PMSTPCOL PEmails

From: Agles, James [mailto:jaagles@STPEGS.COM]
Sent: Friday, February 11, 2011 3:41 PM
To: Tai, Tom
Cc: Wunder, George
Subject: DRAFT Revised 10.2 responses

As discussed with NRC staff at the public meeting on February 2, 2011, we are providing draft revised responses to RAI 10.02-1 through 10.02-8. The date for submitting these responses formally on the docket will be based on feedback provided from the staff, which is anticipated on Wednesday February 16, 2011.

Figure 10.2-5 Turbine Overspeed Trip System Functional Diagram

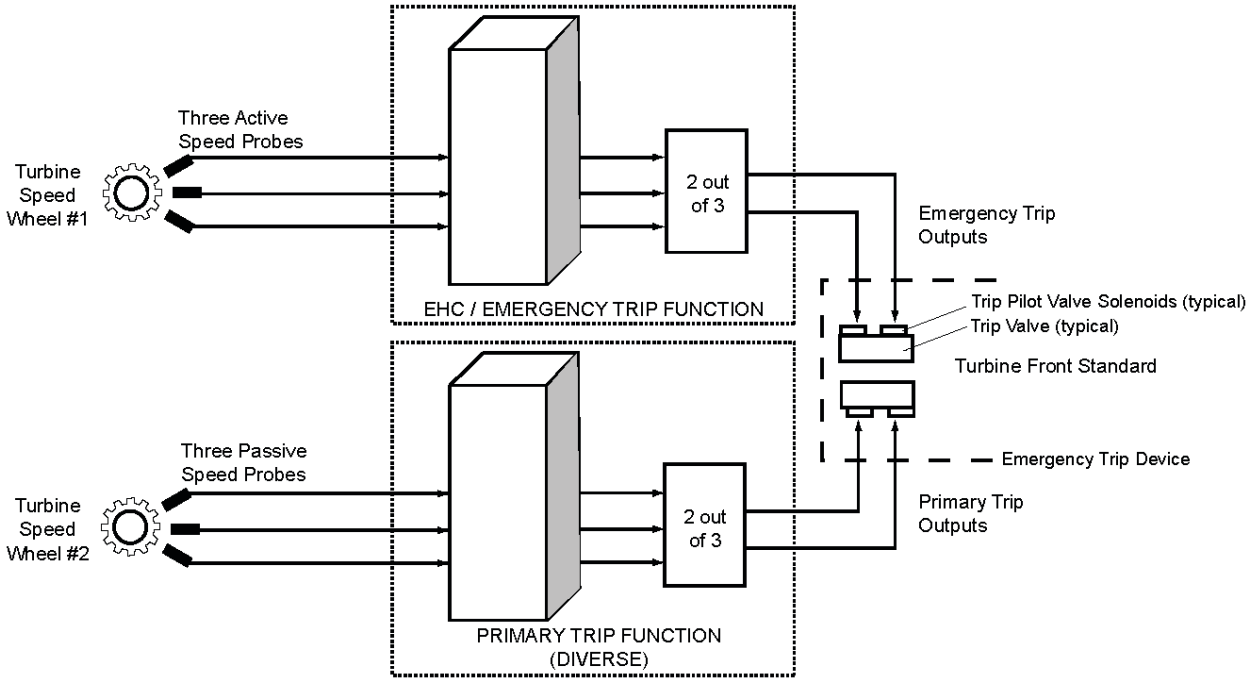
In STP response to staff's RAI 10.2-2, the staff noted that the turbine trip set-points for the primary and emergency backup electrical overspeed systems are 110 and 111 percent of its rated speed, respectively. The staff finds these overspeed trip systems conform to the guidance specified in Items 2.C and 2.D of SRP Section 10.2.III, as related to their set-points. However, the applicant did not provide the schematics and logic diagrams for the two electric overspeed systems, as requested in the RAI 10.2-2. The staff is unable to conclude that the applicant has provided sufficient information for the two electrical overspeed control systems without these schematics and an associated ITAAC in this regard. Therefore, the staff requests the applicant to provide the following:

The overspeed protection system consists of the diverse primary overspeed trip function and the emergency overspeed trip function, as illustrated in the attached figure. Relative to each other the primary and emergency overspeed trip functions are independent, redundant and diverse up to the trip pilot valve solenoids on the trip valves. The trip valves are redundant and independent.

The following figure will be added to COLA Part 2, Tier 2, Section 10.2.

MAIN TURBINE OVERSPEED TRIP HYDRAULIC CONTROL DIAGRAM
RAI 10.02-7

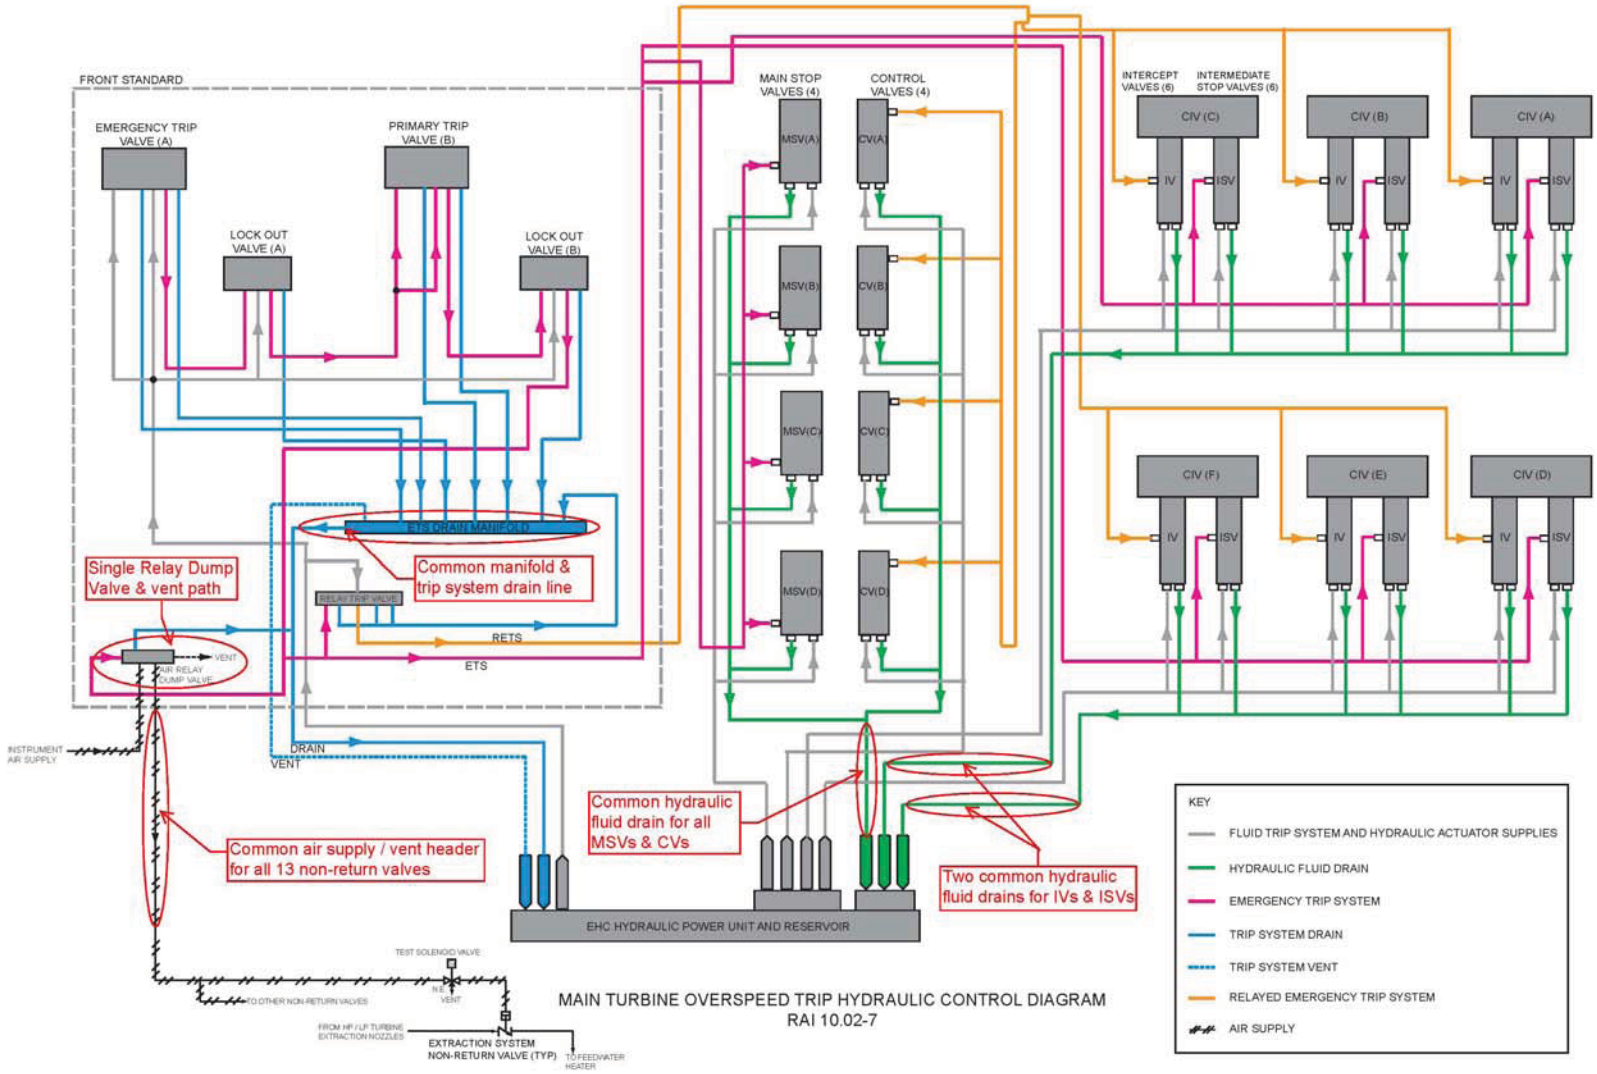
1. The description of the turbine overspeed protection systems (including air and hydraulic systems/interfaces as applicable) need to clearly indicate what parts are shared between the primary and emergency turbine trip systems. For example, shared air and hydraulic dump lines and components such as dump valves and reservoirs need to be described in the FSAR. For clarity, the response should include schematic diagrams that show these flow paths, applicable components, and valves being actuated.

Figure 10.2-5, Turbine Overspeed Trip System Functional Diagram, was added to COLA Part 2, Tier 2, Section 10.2 in response to RAI 10.02-4, and depicts the electrical portion of this system. As indicated in that figure, the primary overspeed trip system and the emergency overspeed trip system are completely separate and independent, up to and including the trip valves.

Although detailed design is not included in the COLA, the attached diagram is included in this RAI response for clarity.
